WATER POLLUTION CONTROL AUTHORITY

JULY 22, 2020
AGENDA

Subject: Beardsley Park Force Main Analysis located in Trumbull, CT

Potential Test Pit Locations
Beardsley PS
CC-06
CC-99
CC-05
CC-04
CC-03
CC-97
CC-94B
CC-94
CC-91A
CC-92
Beardsley Park
Bunnells Pond
Glenwood Park
Reservoir / Whiskey Hill
Vought Ave
Grandview Ave
City View Ave
Sylvan St
Soundview Ave
Hollywood Ave
Balsam Ave
Alba Ave
Woodlawn Ave
Rita Ave
Dodd Ave
Edwards St
Virginia Ave
Louisiana Ave
Pennsylvania Ave
Ohio Ave
Texas Ave
Livingston Pl
Edna Ave
Alpine St

RIVER ROAD
PLAN & PROFILE OF FORCE MAIN
TRUMBULL, CONN.

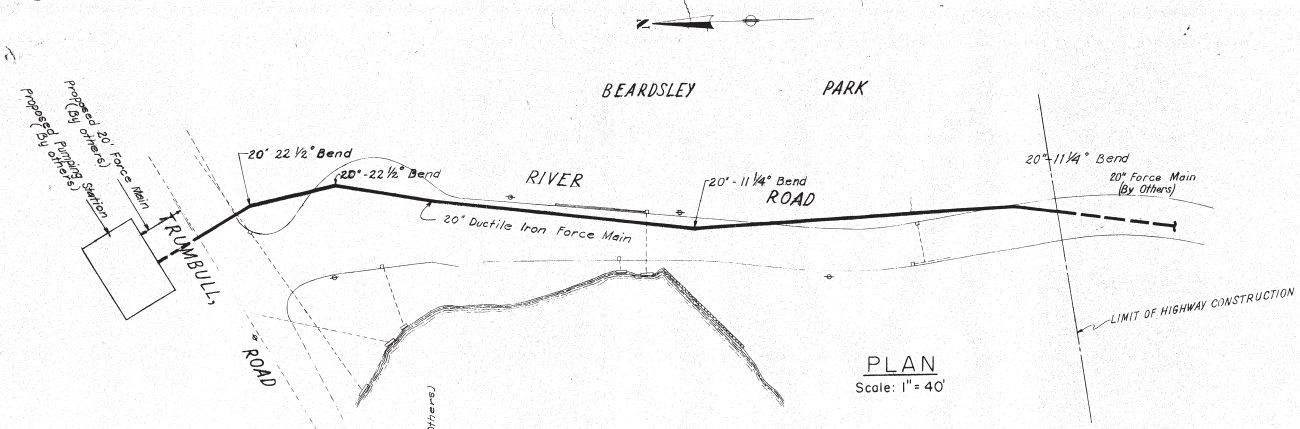
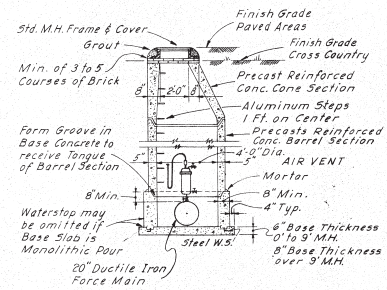
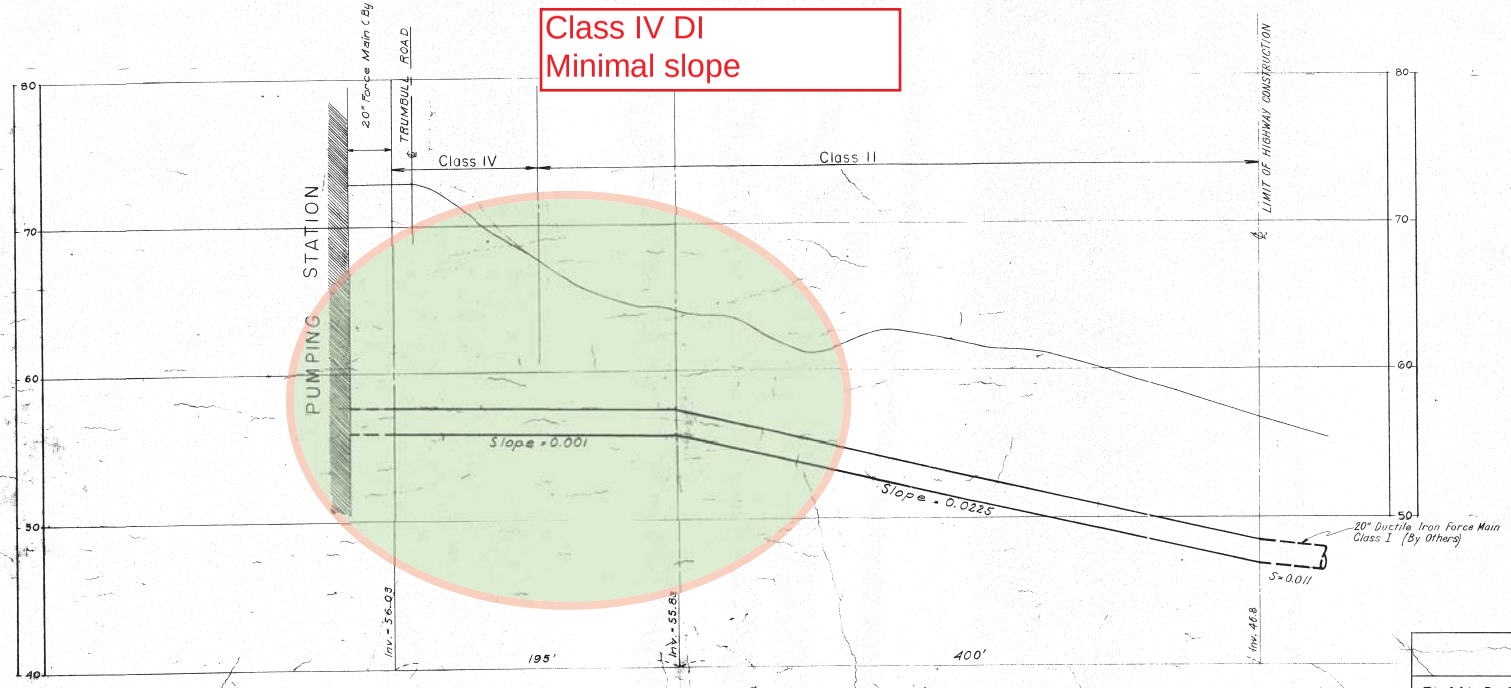
2. Perform a single test pit inspection of the 20" ductile iron pipe located near the pump station on the north shore of the river. This investigation would acquire data to compare to that

obtained from the 2020 failure to determine if the 2020 failure was an isolated incident or indicative of a greater length of the force main. See pages 6 and 7 of this document.

Class IV DI
Minimal slope

SELTSAM ROAD EXT. AND RTE 8&25 CROSSING

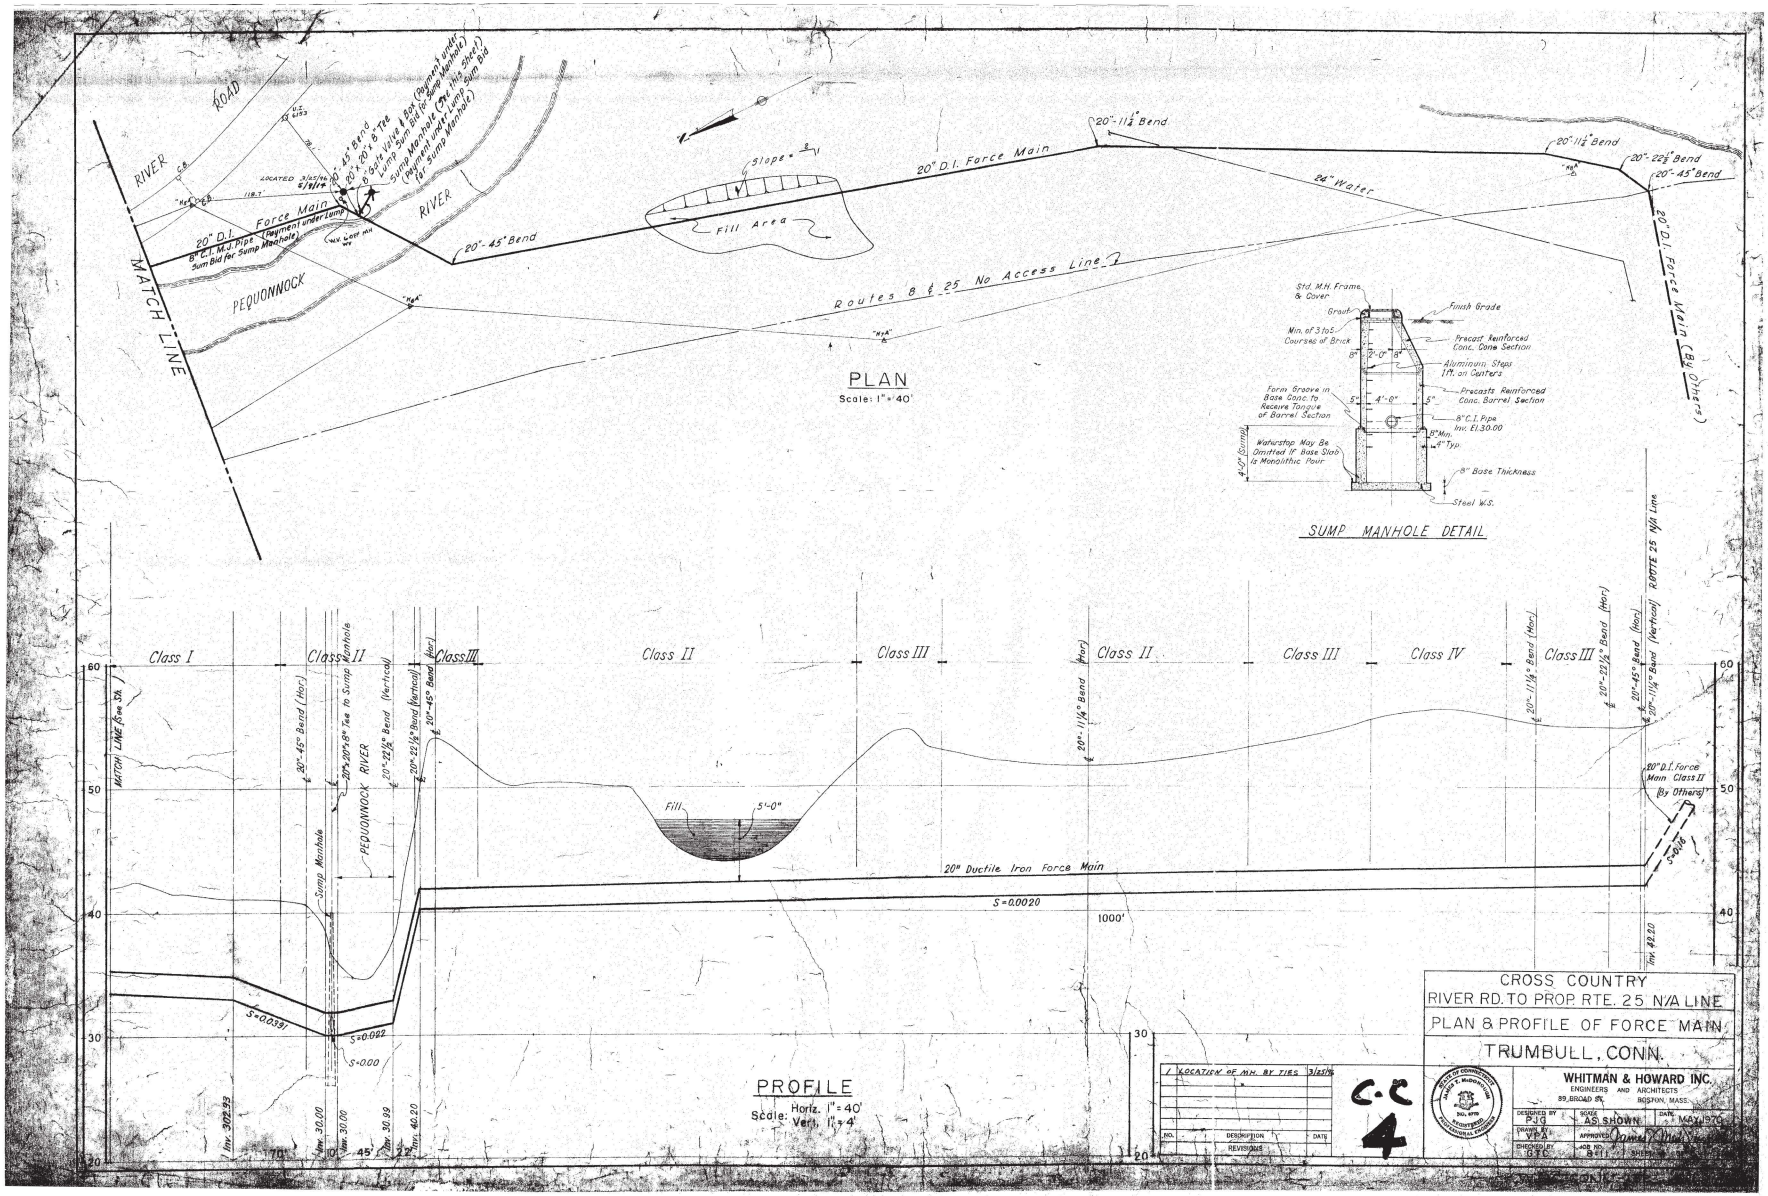
3. Perform a single test pit inspection of the 20" ductile iron pipe located at the low point in the force main along Seltsam Road. This point in the system may see similar mechanisms of deterioration as locations near the pump station as this is a belly in the run with minimal slope both upstream and downstream. See page 12 of this document.

RESERVOIR AVE, LAKE ST. & SYLVAN AVE NORTH

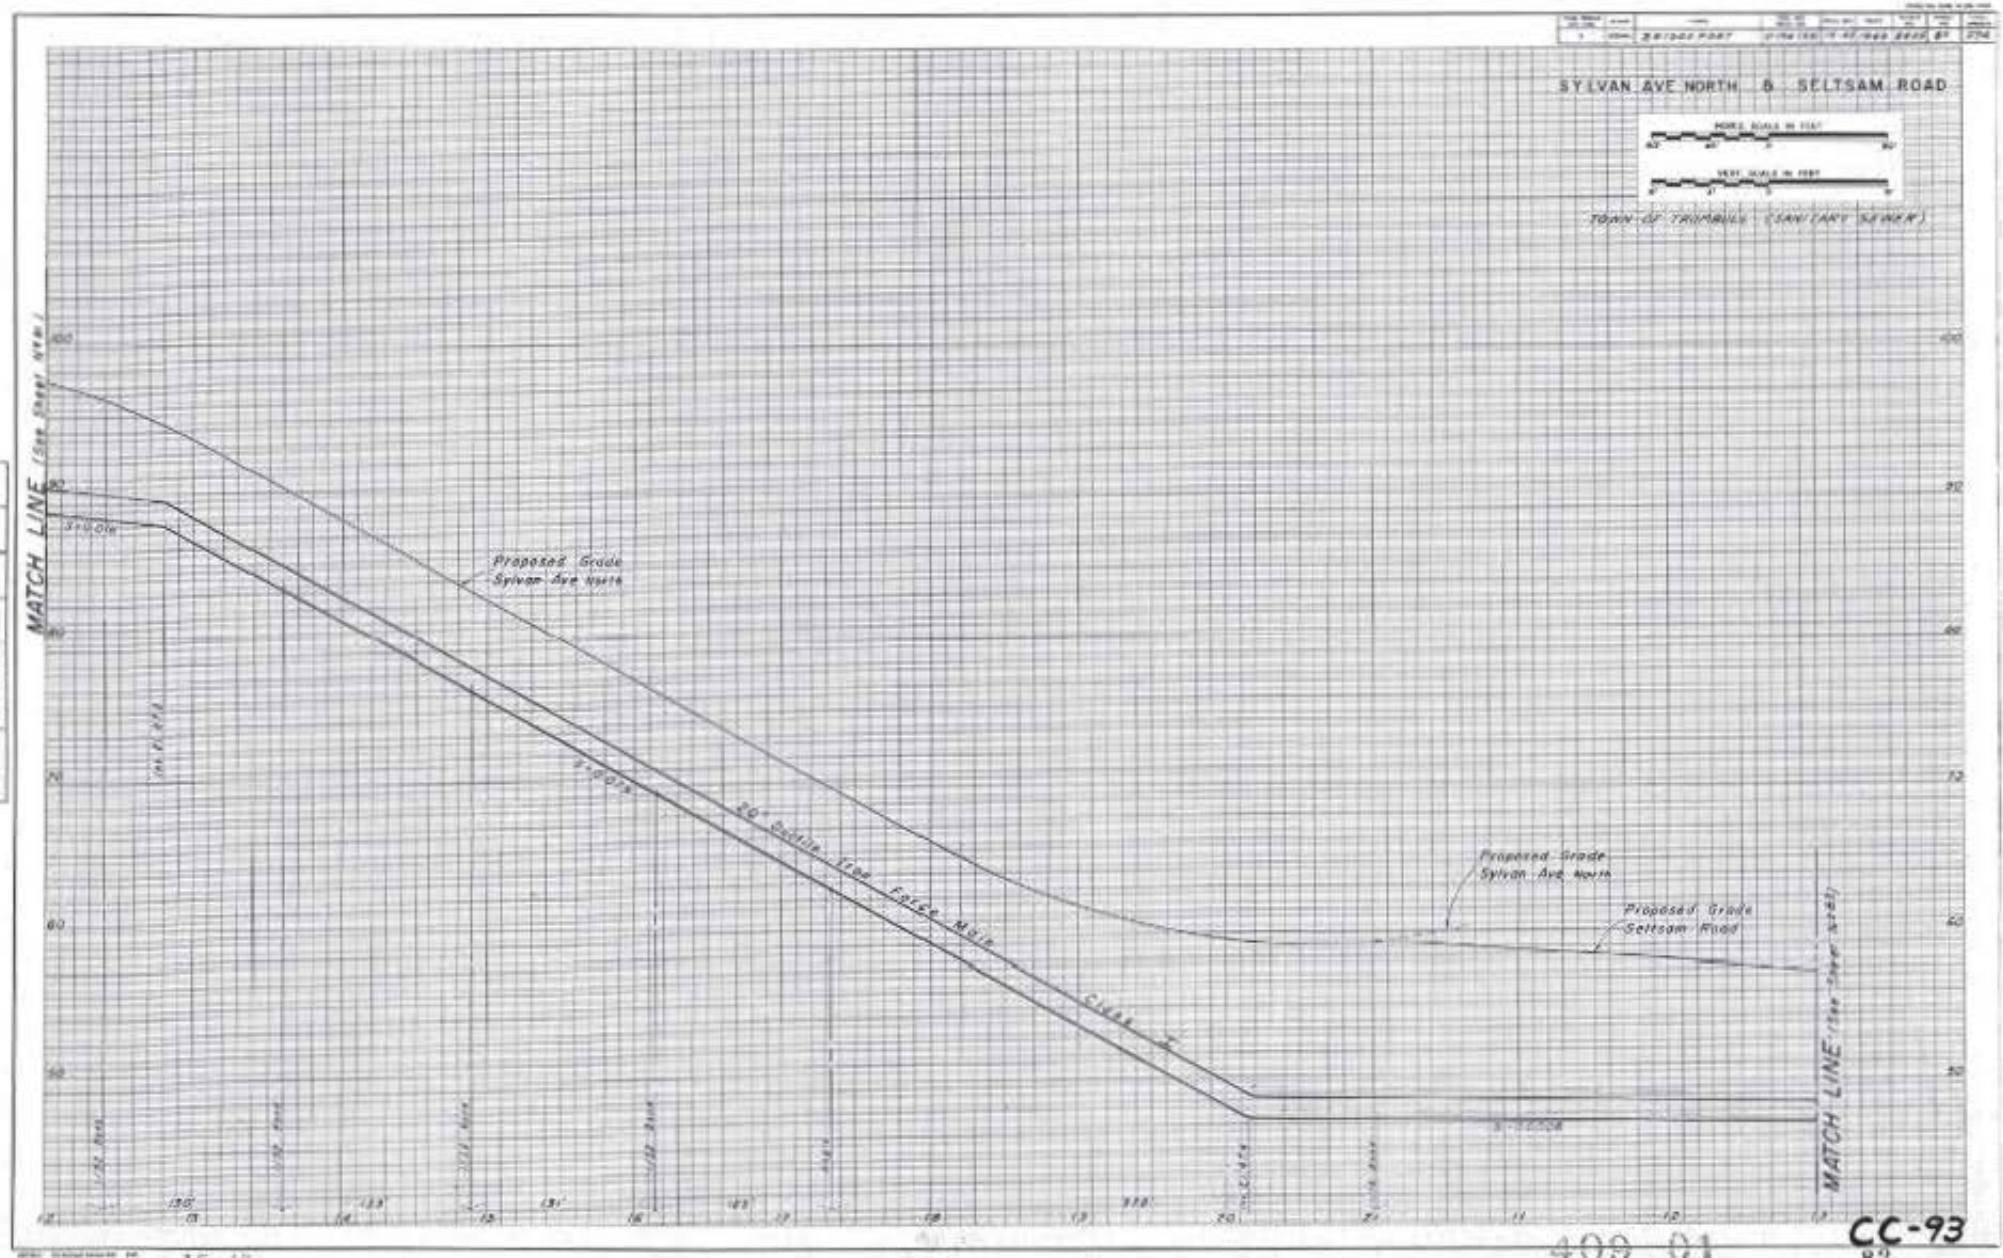
1. Perform a test pit inspection of the 20" ductile iron pipe located near each ARV, for a total of two test pits and inspections. Inspection at each ARV, by confined space entry into the below-grade structures, may provide some information regarding the formation of a potential headspace and possible H_2S thinning at the crown of the 20" ductile iron pipe. This type of inspection would be limited to the upper half of the pipe circumference. A full test pit inspection, including exposing the invert of the pipe and providing access to the full circumference of the pipe would return more conclusive results representative of the system. See pages 11 and 14 of this document.

Class I DI
ARV - accessible through CSE
Potential for headspace formation
